ISO New England Operating Procedure No. 18 Metering And Telemetry Criteria (OP-18)

Effective Date: TBD

Figure 9-1. Example Test Scheme for a DC Meter with Voltage Inputs.

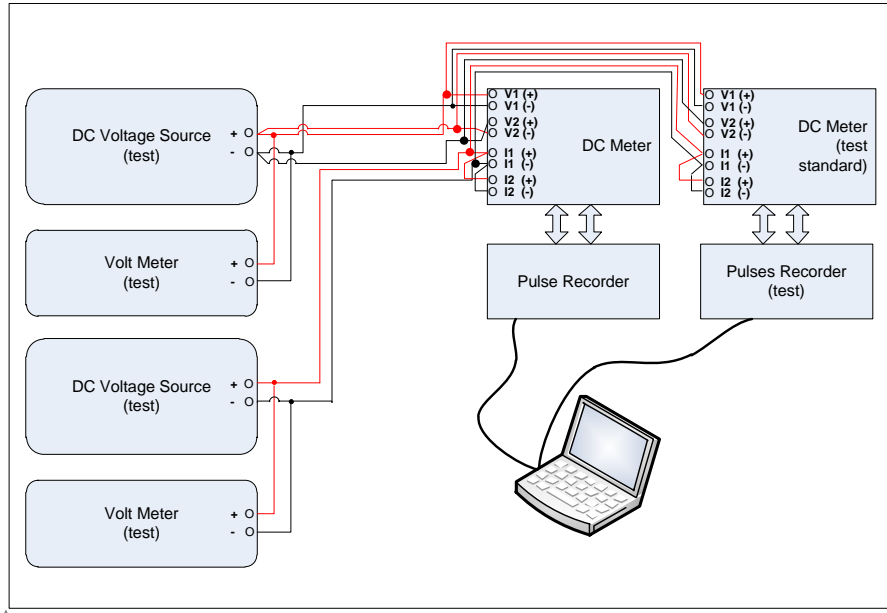
Comment [JC4]: From here through to including Figure 9-2: Tom Succi, Alan Salk & Dave Santa Maria 9/9/2014
